Recall Number:	21V236 — US	2021-201 — Canada
Product:	Turning Point Pin Box	
Date:	04.16.21	Labor Rate: 0.3 Hours Inspection/0.8 Hours Replacement

Purpose

Incorrect Turning Point pin boxes may have been installed on some 5th Wheels, with 10K pin boxes installed instead of 16K pin boxes. A visual inspection is necessary to determine if the incorrect pin box has been installed. If a 10K pin box has been installed, then it must be removed and replaced with a 16K pin box (PN 657275). The inspection and replacement procedures are described in this document.

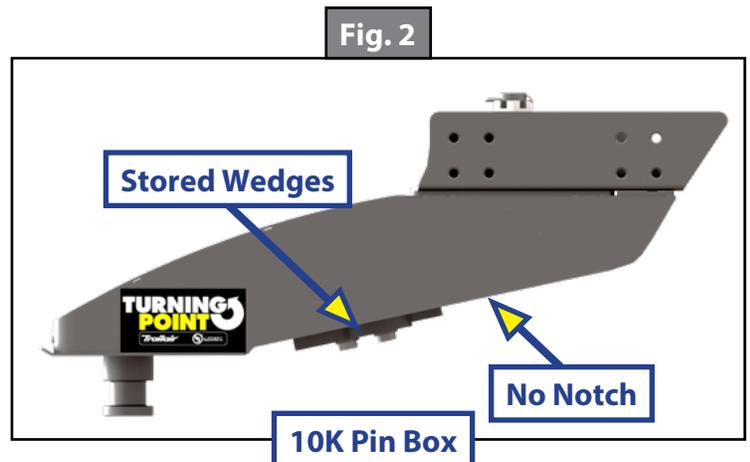
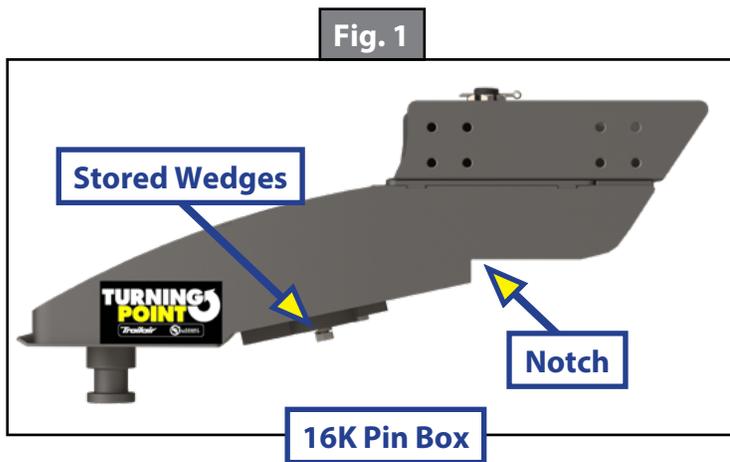
1. Visually examine the bottom side of the pin box profile.
 - A. If there is a notch (Fig. 1) toward the end of the pin box after the stored wedges, it is a 16K pin box. Replacement is not necessary.
 - B. If there is no notch (Fig. 2) where the bottom edge of the pin box extends in a straight line past the stored wedges, it is a 10K pin box and needs to be replaced.
